TECHNICAL SERVICE BULLETIN

SUBJECT: DIFFICULT HOT ENGINE RE-STARTING -
1963 CORVAIR (EXCEPT TURBOCHARGED
MODELS) AND CORVAIR "95"

BULLETIN NO. DR # 589

DATE May 1, 1963

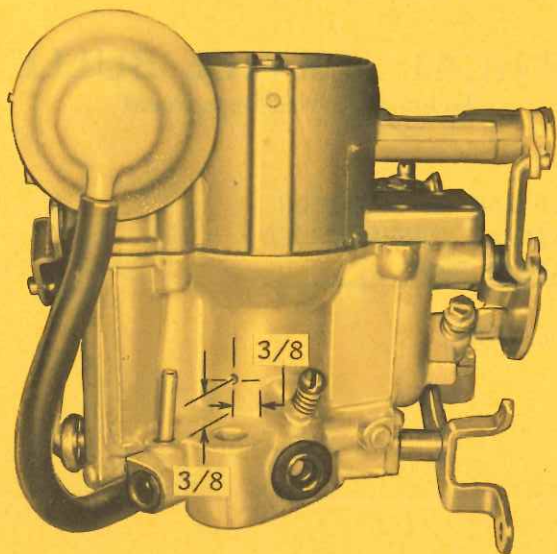
Hot starting time may be reduced considerably by drilling a 1/8" diameter hole through the body of each carburetor as illustrated on Page 2, to provide a vent.

DRILL 1/8" DIA. HOLE
AS SHOWN ABOVE

CAUTION: This vent hole is not recommended for vehicles operating in extremely dusty areas.
